**ARCHITECT'S ADDENDUM**

Addendum Number: 01

RE: Fort Zumwalt School District

Transportation Center

PARTITION TYPE	CMU SIZE	FIRE RATING	FIRE TEST NO.
C1	7 5/8"	2 HR	U905
C2	11 5/8"	2HR	U905
C3	5 5/8"	---	---

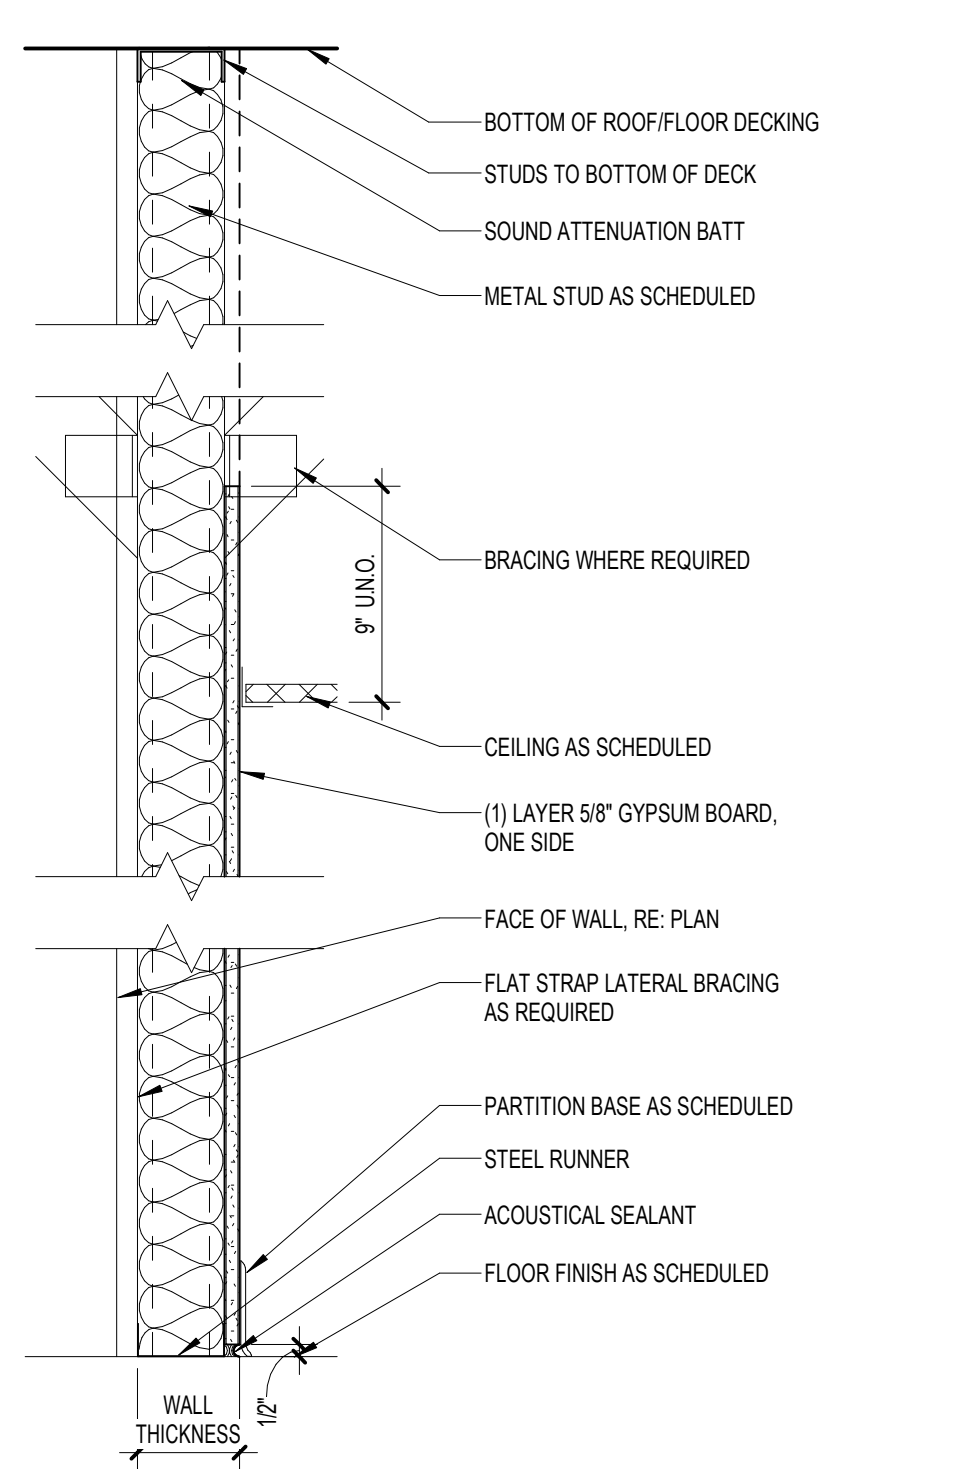
1. G1.01
  - a. Added wall type C3 – 6" nominal width CMU wall.
2. C1
  - a. Added Grading Quantity table
3. C3
  - a. Revised Heavy Duty pavement label in legend to match detail
4. C4
  - a. Added callout for 8" water valve, yard hydrant and rain garden areas. Revised dimensions of pump island.
5. C5
  - a. Revised grading at Rain Garden Area 2. Added location of construction entrance and washdown area
6. C6
  - a. Revised Erosion Control details, added Rain Garden Area details

**RAIN GARDEN PROFILE**

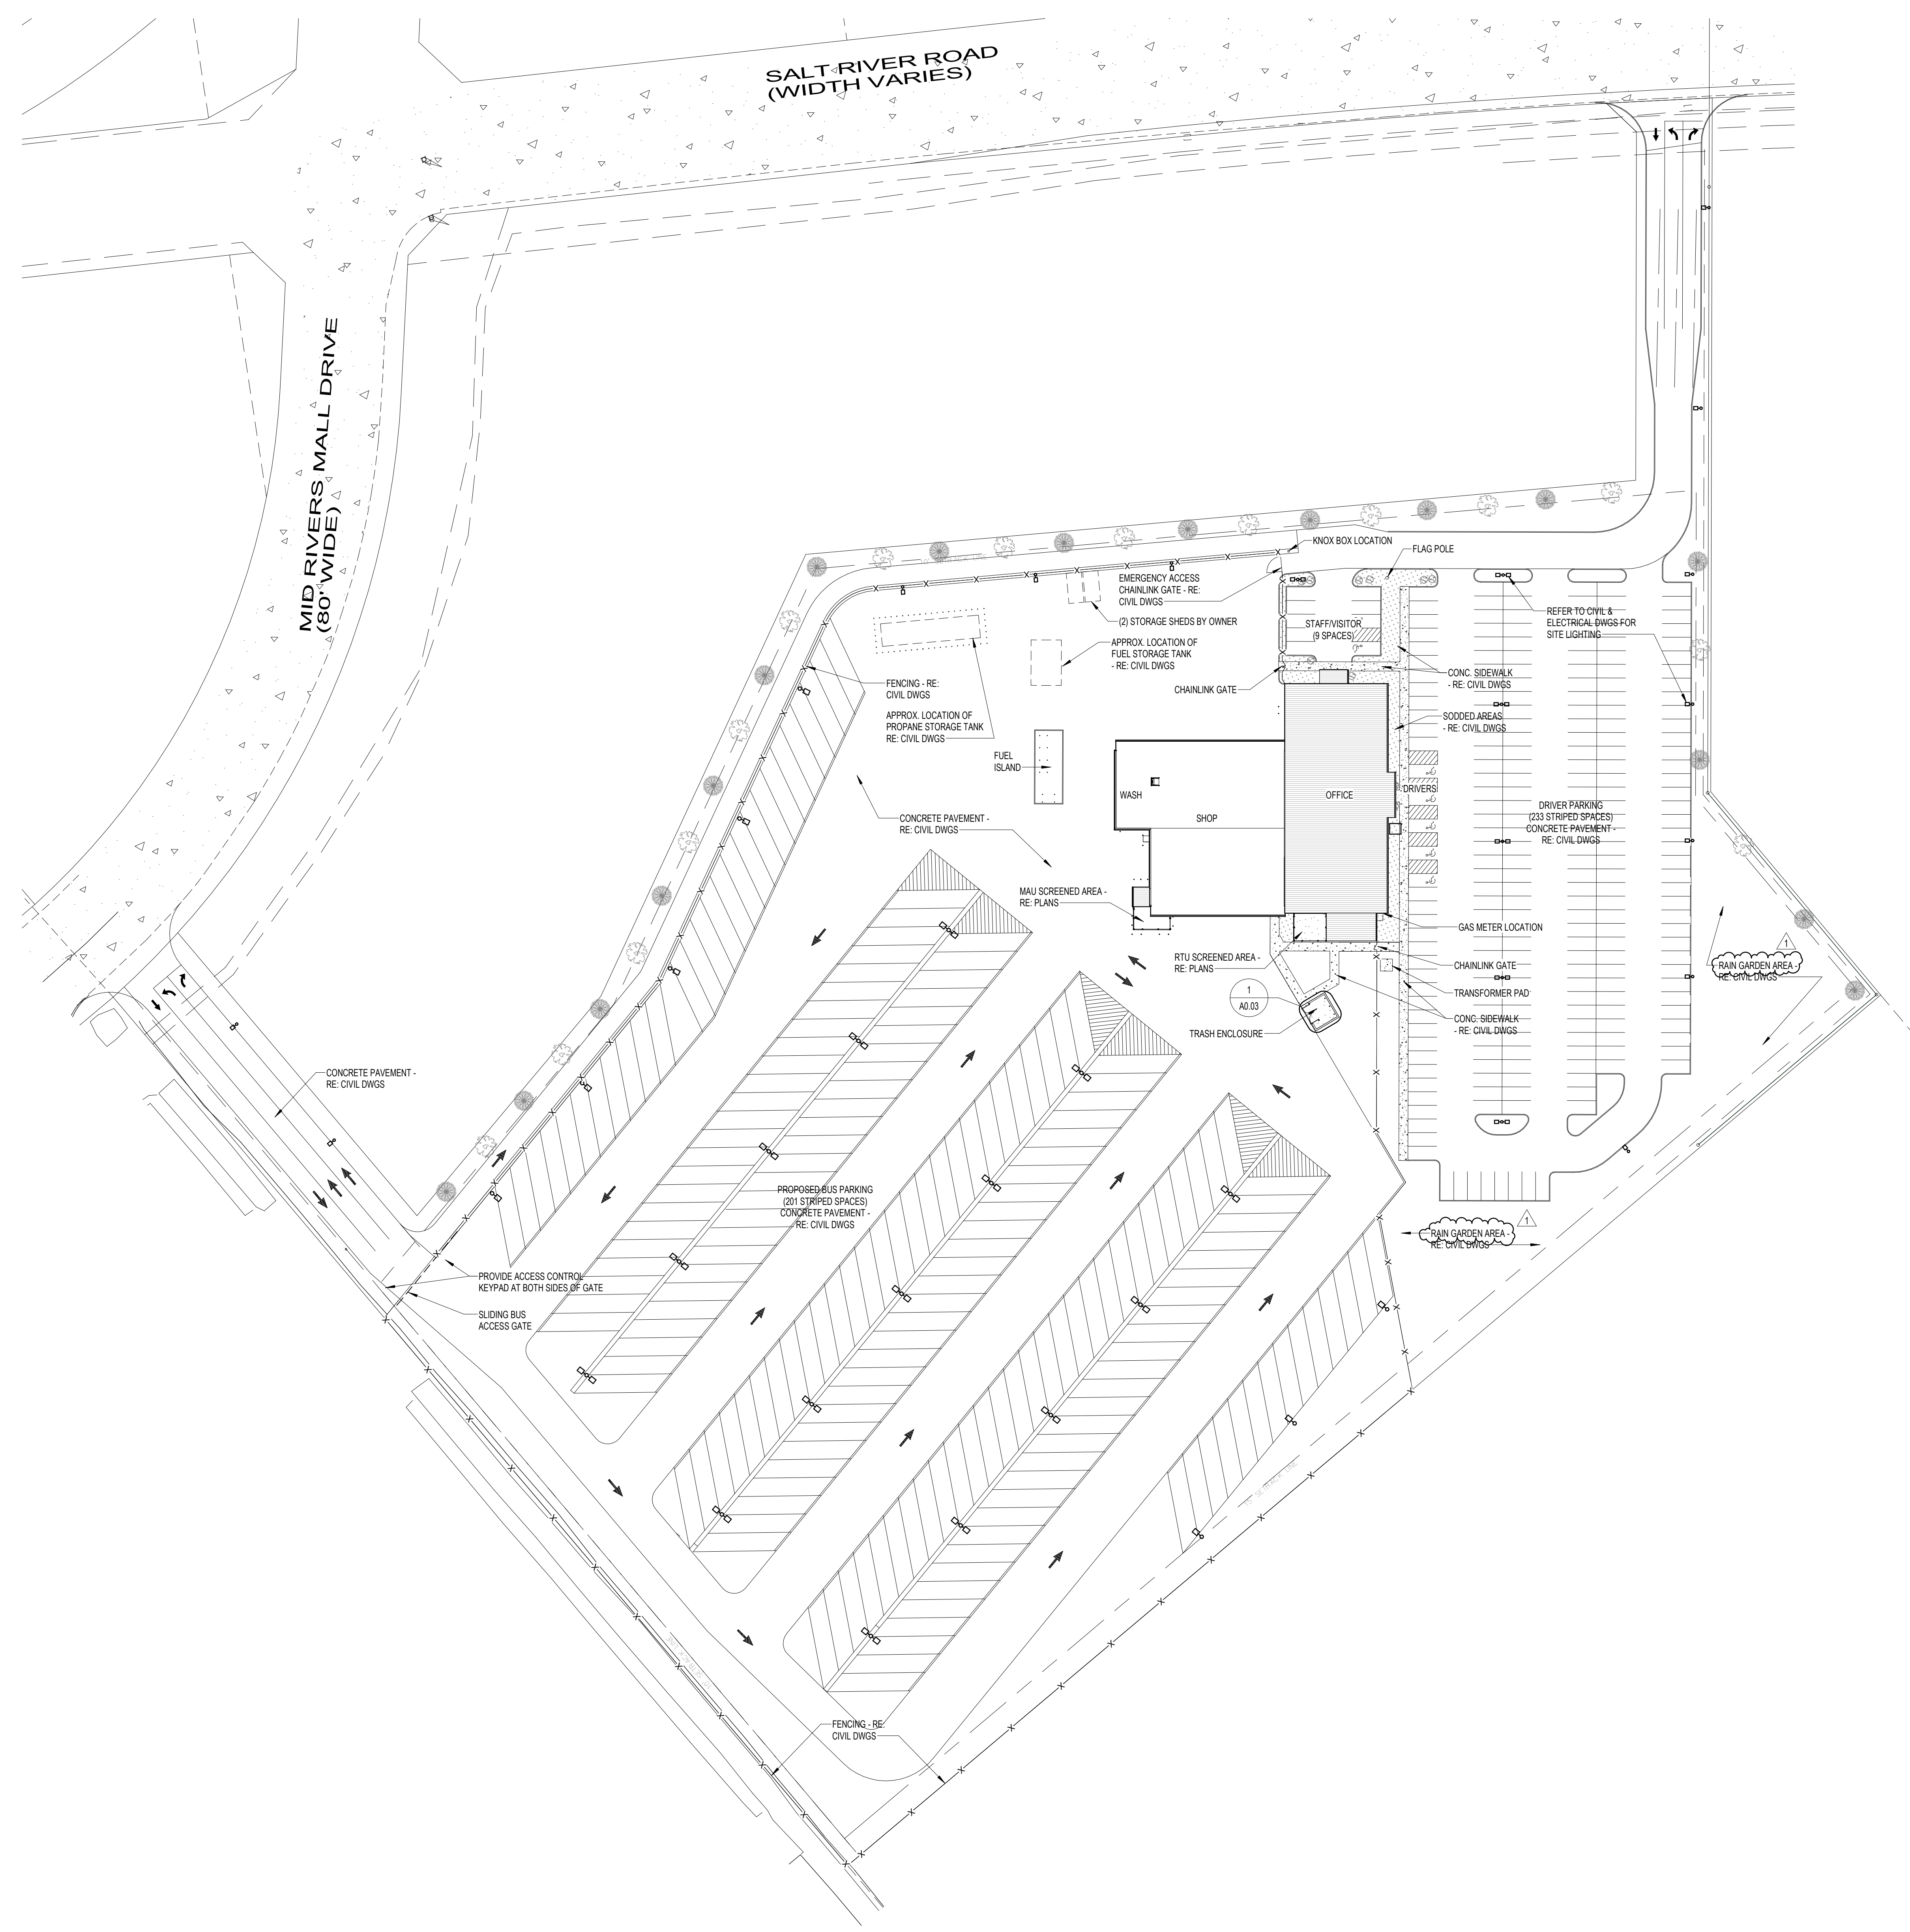
7. C9
  - a. Removed details for trash enclosure, fence and pipe bollard
8. C10
  - a. Revised sewer details, added Rain Garden Plan View.
9. A0.02
  - a. Revise note "BIO-RETENTION AREA" to "RAIN GARDEN AREA" per Civil.

1  
A0.02 OVERALL SITE PLAN  
1" = 50'-0"

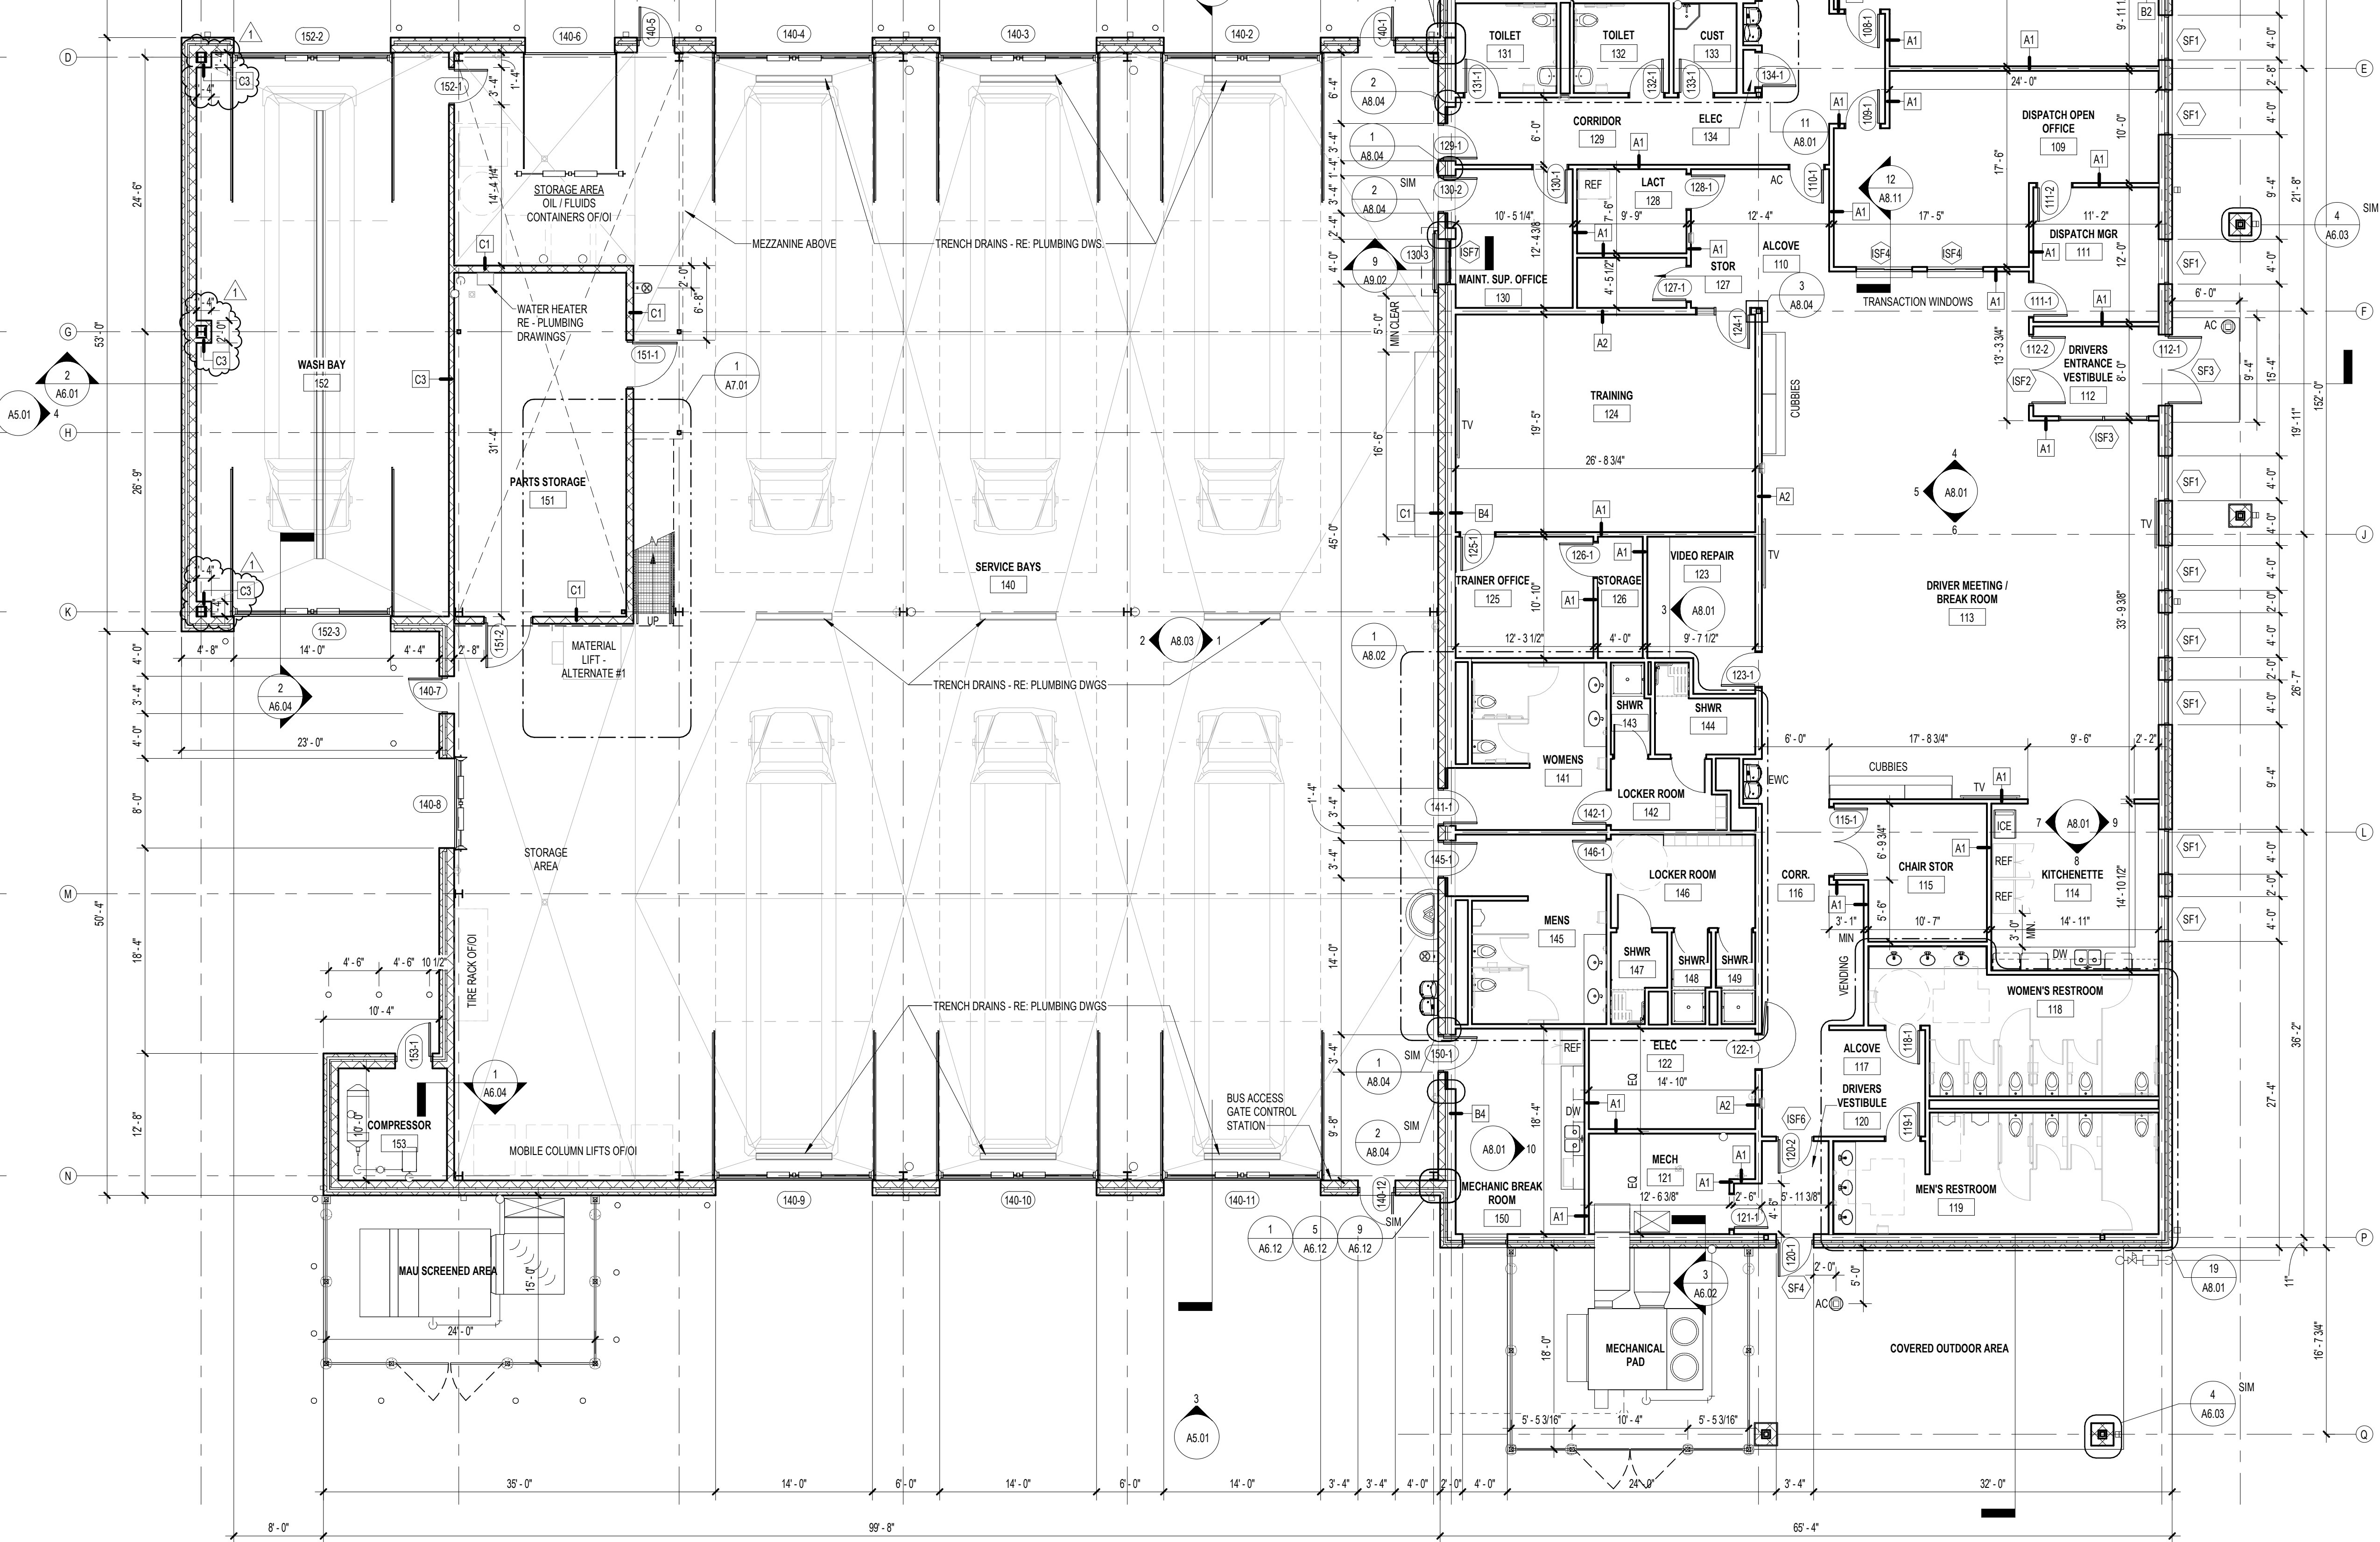
Q - On sheet A0.02 it refers to a Bio Retention area – it is not shown on civil utility plan, please advise.

- b. Revise note "LANDSCAPE AREA" to "RAIN GARDEN AREA" per Civil.
10. A2.01
  - a. Added enclosures at the columns located in Wash Bay 152.
11. A3.01
  - a. Added note 9 under General Reflected Ceiling Plan Notes.

A – See revised drawings this addendum
